Quality & Technical Improvement

Effected Part	: -HS200/HS250/HS300
Date Of Effective Change	: -January 2013
Type of Change	: -Phased in.

Previous Design

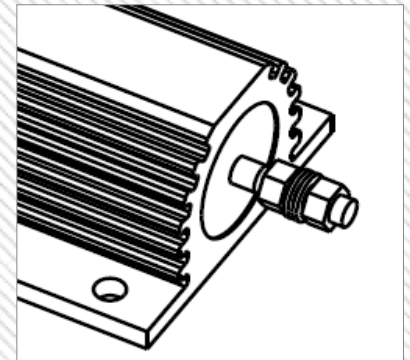
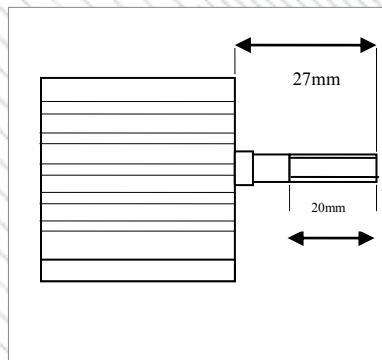
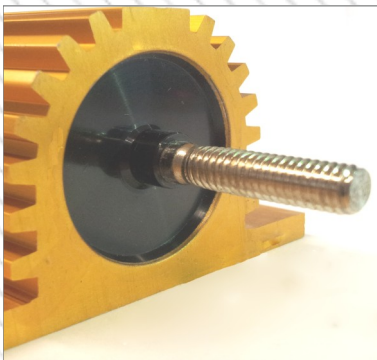
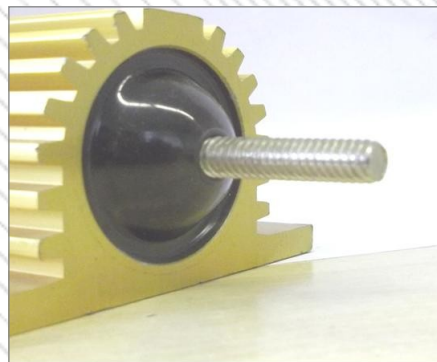
Due to continual product and process improvements the HS200, HS250 and HS300 have a new moulded end profile and improved terminal. This has been adapted to ensure no damage is occurred to the moulded surface whilst tightening of the nut which previously has caused failure in some product. The Photo's below show the new and old moulded ends and terminals for your comparison. The terminals and moulding are the only change to the product.
